Item ID: D350-607-511MB Accept *N900040100* Setup Start *NS1*
 Revision ID: Stop *NS2*
 Item Name: AS350/AS355 Quick Release Basket/Long Cargo Tube Mounting Provisions, Fits LH/RH (Matte Black)
 Start Date: 5/15/2017 Start Qty: 2.00 *2* Cust Item ID:
 Required Date: 5/19/2017 Req'd Qty: 2.00 *2* Customer:
 Reference: SCHEDULED/C MAT BLACK
 Approvals: Process Plan:  Date: APR 24 2017 Tooling: Date: Run Start *NR1*
 QC: Date: SPC (Y/N): Date: Stop *NR2*

DART SERVICE INSTRUCTION

TO AMEND INSTALLATION INSTRUCTIONS D350-607-3 Rev.D,
INSTALLATION INSTRUCTIONS D350-607-4 Rev. C AND
INSTRUCTIONS FOR CONTINUED AIRWORTHINESS ICA-D350-607 REV. 6
REF TCCA STC: SH94-14
REF FAA STC: SR00213NY
REF EASA STC: EASA.10016996
REF BRAZILIAN STC: 2007S03-03/-04/-05/-06

FIGURE 1: INSTALLATION OF D4775-041 FWD STRUT

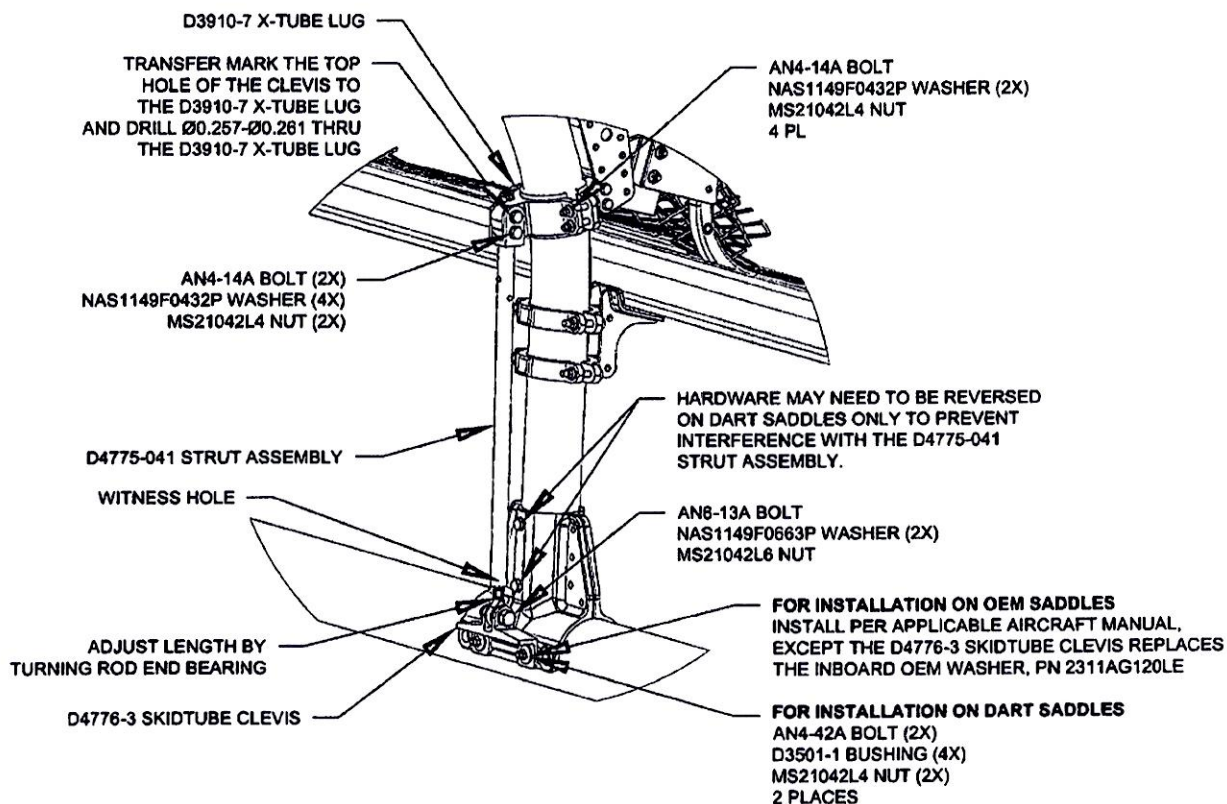
3.1 Substitute the Forward Lower D3910-5 X-Tube Lug with the D3910-7 X-Tube Lug as shown in Figure 1.

3.2 Install the forward D4775-041 Strut Assembly. Transfer mark from the upper hole on the clevis of the D4775-041 Strut Assembly to the D3910-7 X-tube Lug and drill thru the lug $\varnothing 0.257$ - $\varnothing 0.261$ as shown in Figure 1. Touch up chemical conversion coating per MIL-DTL-5541. Check the witness holes located at the bottom end of the D4775-041 Strut Assemblies to ensure that the thread from the rod end extends past the witness hole.
Torque MS21042L4/-4 nuts to 50-70 in-lbs (5.7-7.9 N-m). Torque MS21042L6/-6 nuts to 160-190 in-lbs (18.1-21.5 N-m).
